South Texas Project Electric Generating Station P.O. Box 289 Wadsworth, Texas 77483

U7-C-STP-NRC-100056

South Texas Project  
Units 3 and 4  
Docket No. 52-001  
Response to Request for Additional Information

This letter provides the response to Request for Additional Information (RAI) Letter Number 12 question 03.02.02-1 related to the application to amend the ABWR DCD Amendment Part 2, Tier 2, Section 3.2.

FIGURE 6.2-39 ATMOSPHERIC CONTROL SYSTEM P&ID (Sheet 2 of 3)  
 ABWR DCD/Tier 2 Rev.5

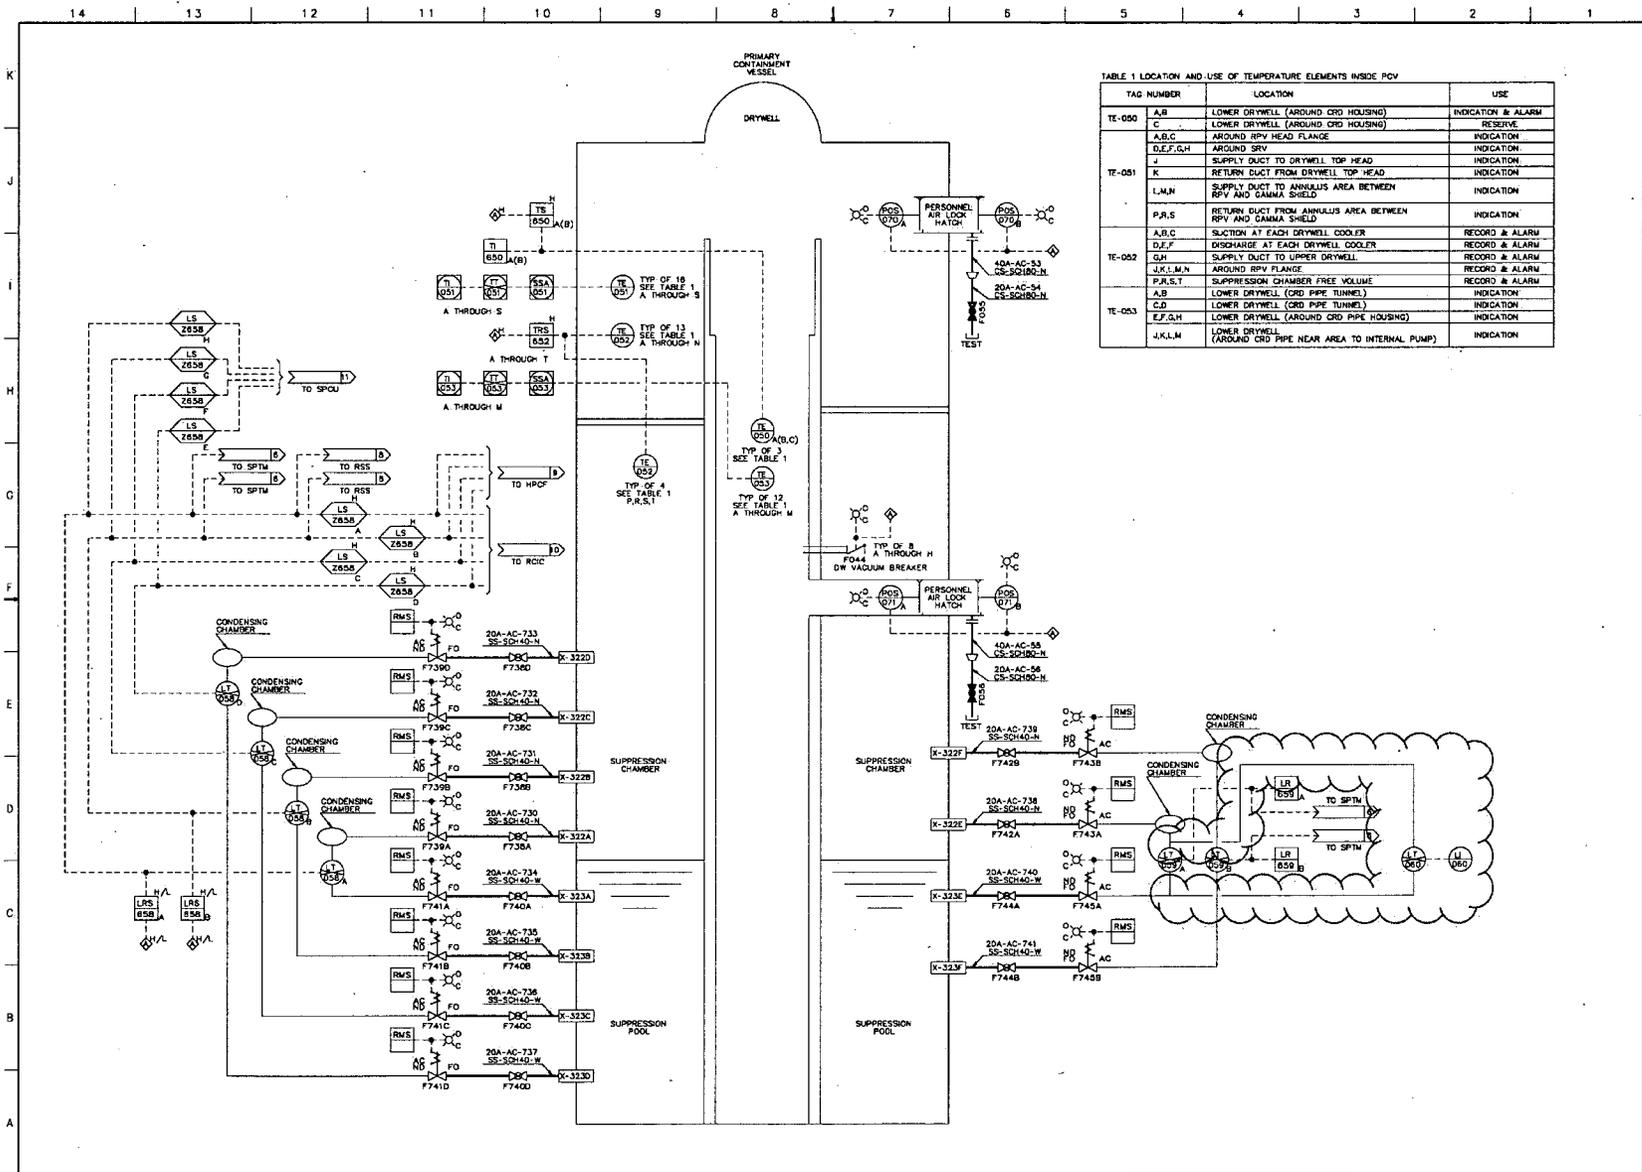
The staff request the applicant to clarify how and where the connection is made from which the AFI system gets its instrumentation signals and to demonstrate that the instrumentation included in the new AFI system does not create any potential for inadvertent actuation or creates challenges to current safety systems.

The instrumentation connections for the AFI system are shown in the marked-up drawings for FSAR Figure 5.1-3, Sheet 5 provided in the original amendment application submittal and in updated Figure 6.2-39, Sheets 2 and 3, attached to this RAI, which supersedes the Figure 6.2-39 markups provided in the original submittal. There are no automated control systems or functions for the AFI system, because it is a manually operated system. The instrumentation for the AFI system only includes indicators that are for operator information. In addition, the water level and pressure instrumentation in the AFI pump room uses separate transmitters and power supply from existing instrumentation. As noted in the response to RAI 03.02.02-1, the safety classification of the instrumentation and piping for the AFI system is the same as that for the existing instrumentation to which it is connected. Those requirements are identified in a mark-up to Table 3.2-1 which is included with that response. Consequently, the AFI system does not create any potential for inadvertent actuation or challenges to current safety systems.
